SUBDIVISION REVIEW SHEET

CASE NO.: C8-2022-0287.1A

SUBDIVISION NAME: Three Hills Apartments

CITY OF AUSTIN –DEVELOPMENT SERVICES DEPARTMENT
SUBDIVISION APPLICATION – MASTER COMMENT REPORT

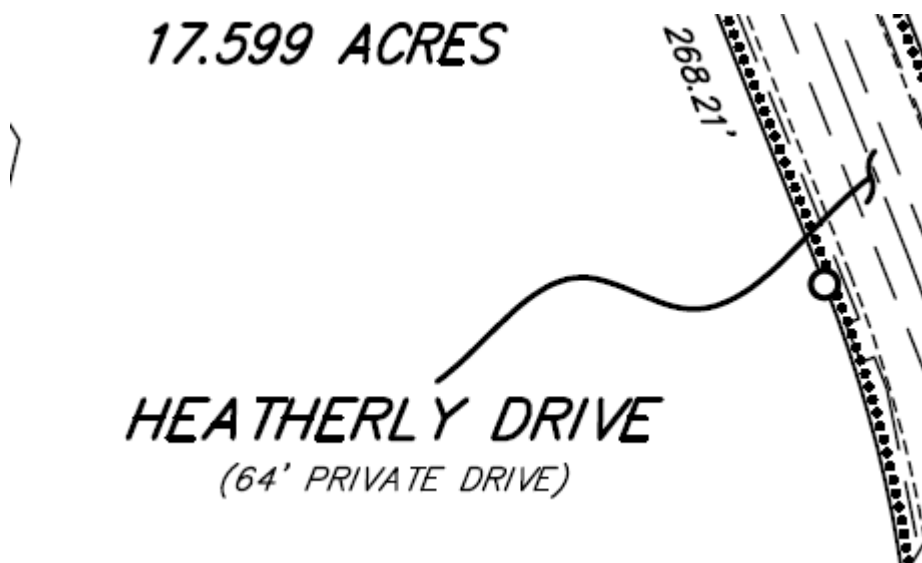
AD1: This plat review is Rejected;

AD2: Please add the label, **HEATHERLY DR** within the R.O.W, and not as a call out

NOTE: Addressing recommends to please place labels directly on the ROW and not as a callout on a parcel
